## Site 68 Sydney Olympic Park

Section B-B East-West	
Scale	1:250 @ A1 1:500 @A3
Drawn	Checked
Project No.	S11611
Status	s96 Application
Plot Date	23/6/2015 5:12 PM
Plot File	S:\11600-11699\s11611_ecove_sopsite68\00_main\cad\plots\DA. \A06.02[04].dwg
Drawing No.	[Revision]

## A06.02[04]

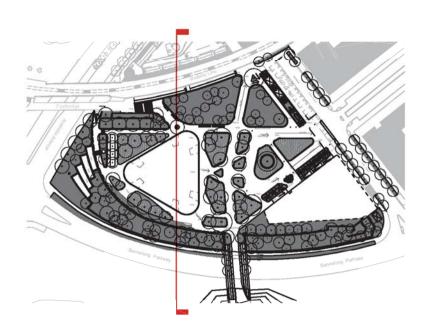
- **Revision 04 Section 96 Amendments**
- A Revision to landscape levels. Tower lobby FFL lowered from10.70 to 10.30. Tower typical floor to floor height levels reduces from 3.2m to 3.1m.
- B Excess plant space on rooftop converted to residential flots. New floor inserted at Level 35.
- C New typical floor inserted at level 25. D - New retail tenancy within existing footprint at grade.
